CITY OF ALBUQUERQUE

**RE: Lot 16 Block 1 Volcano Cliffs Unit 22 SAD 228
8011 Agua Fria Ct. NW
Grading and Drainage Plan
Engineers Stamp Date: 10/29/2020 (D10D003N16)
Pad Certification Date: 5/10/21**

DRAINAGE AND TRANSPORTATION INFORMATION SHEET (REV 11/2018)

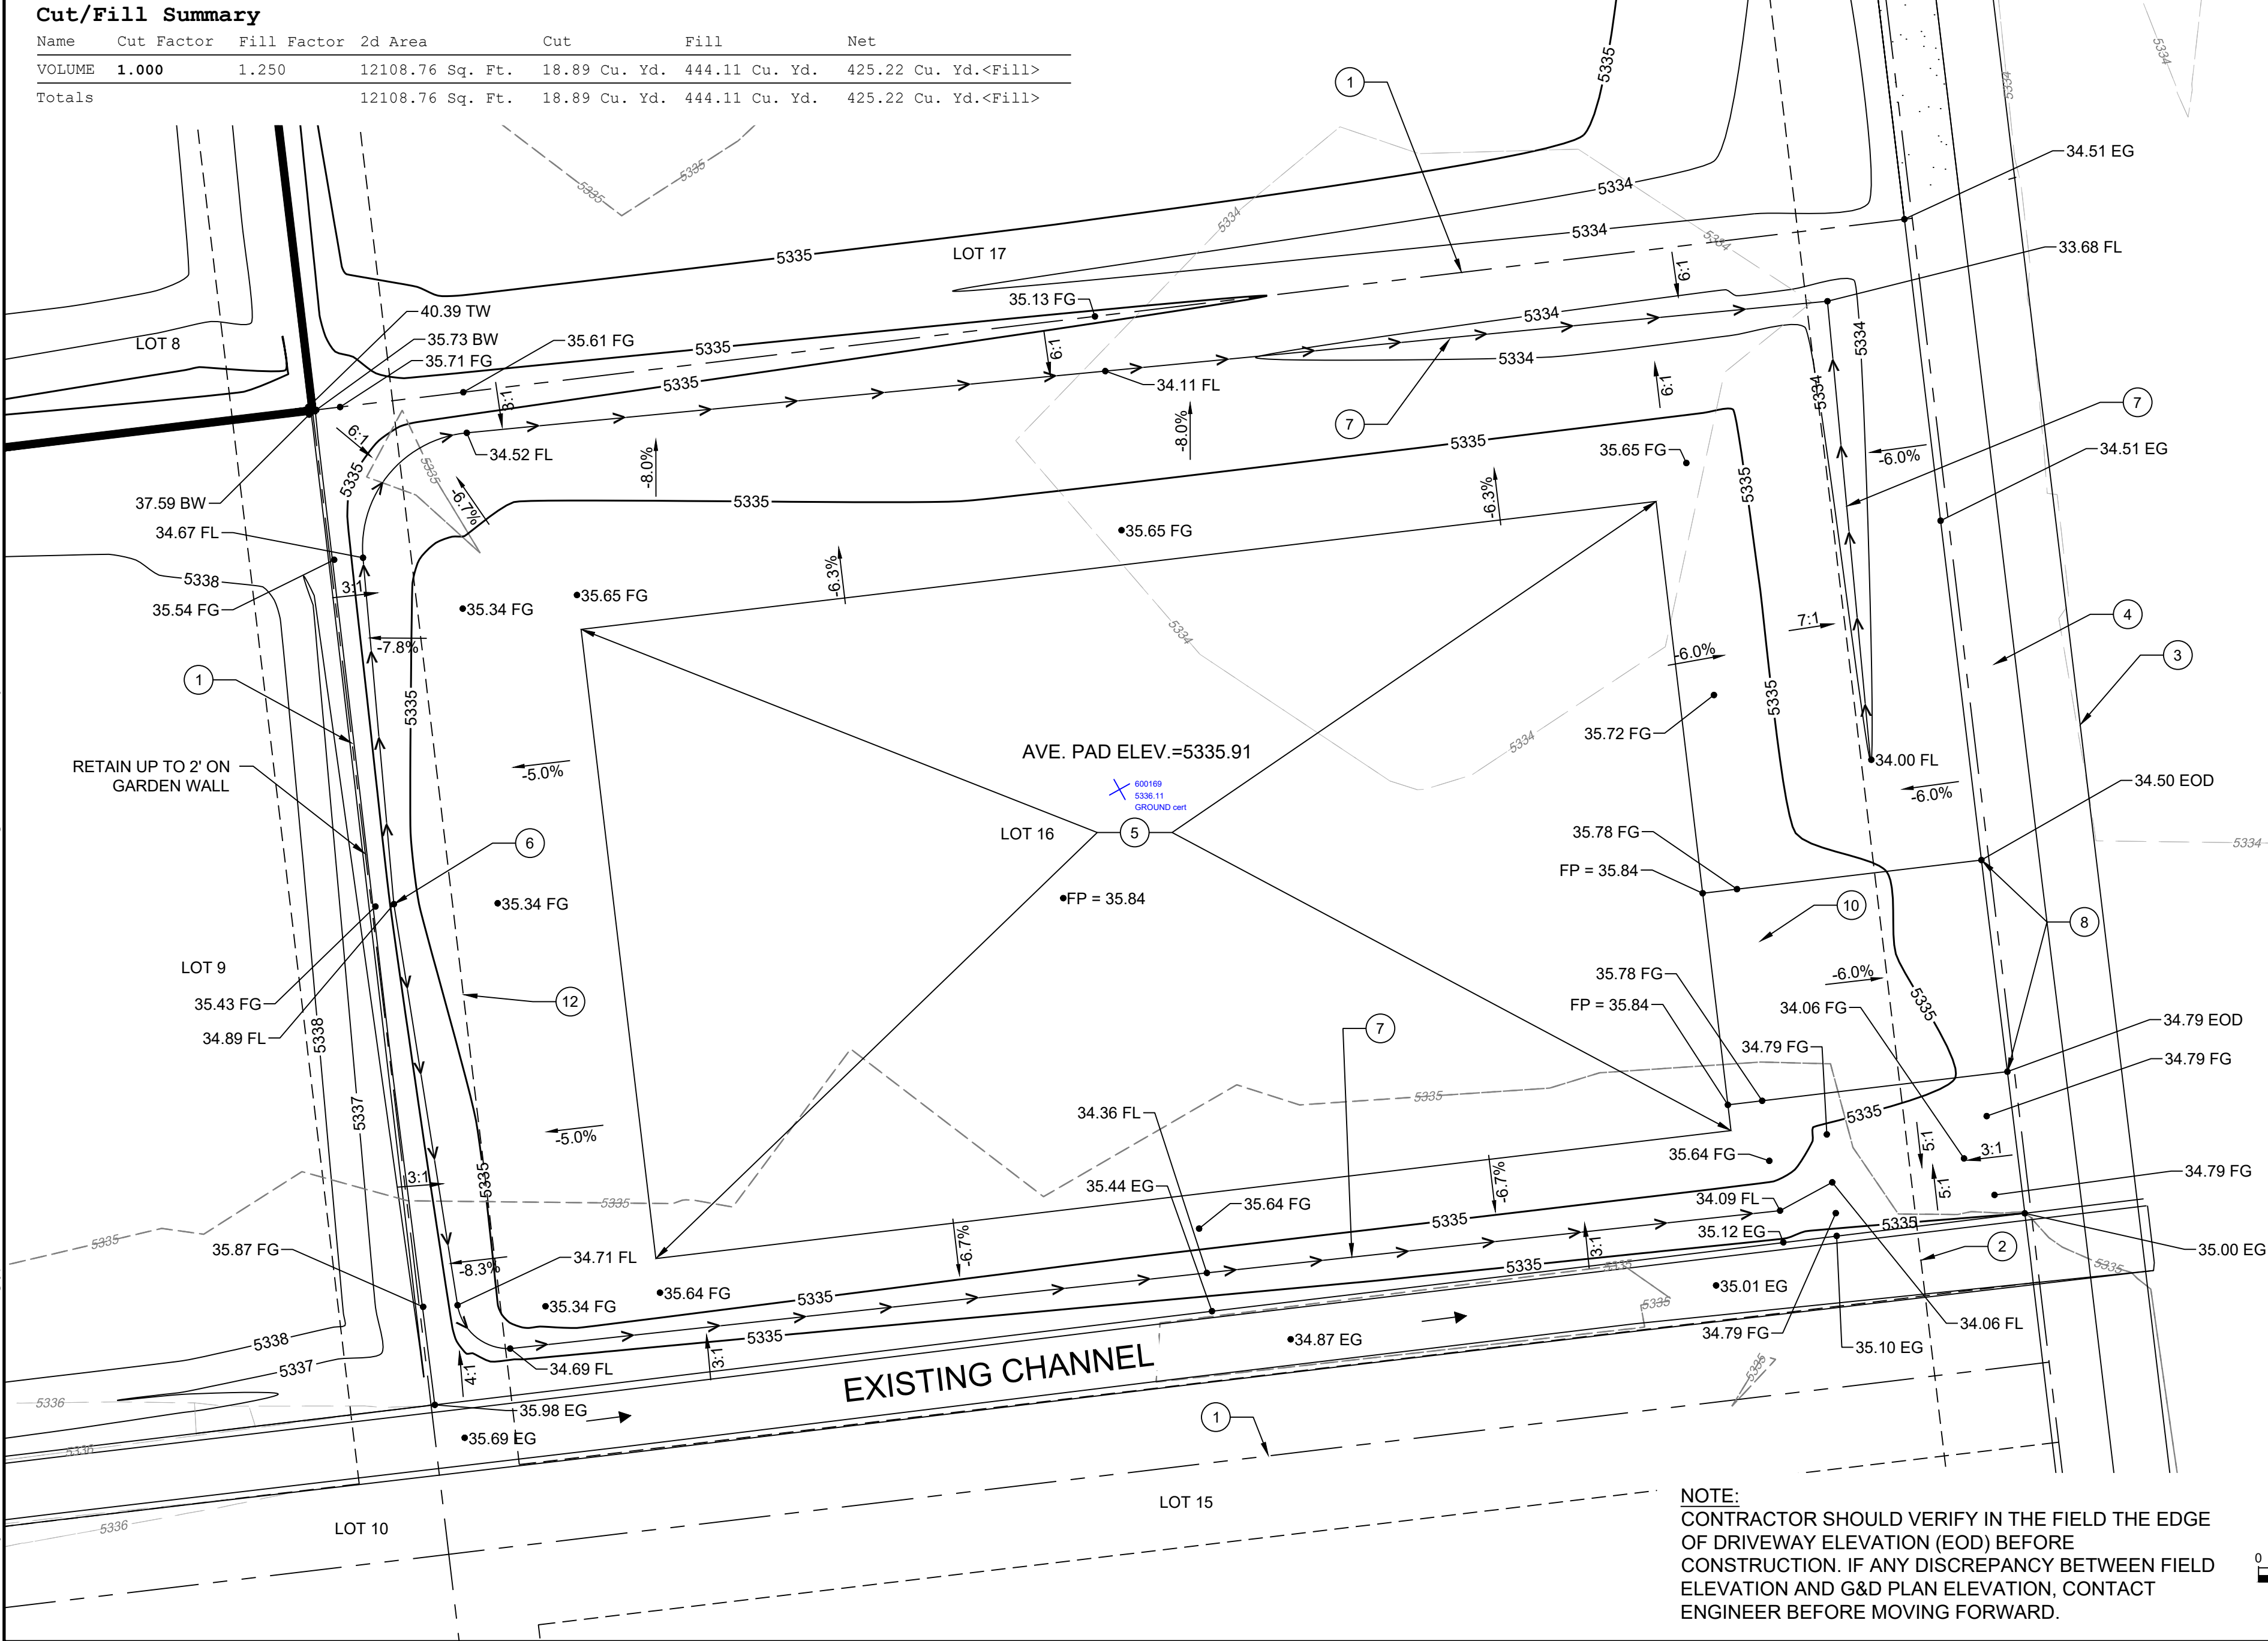
Based upon the information provided in your submittal received 5/14/2021, this plan cannot be approved for Grading Permit until the following comments are addressed.

- Provide the approval letter or email given by Doug Hughes.
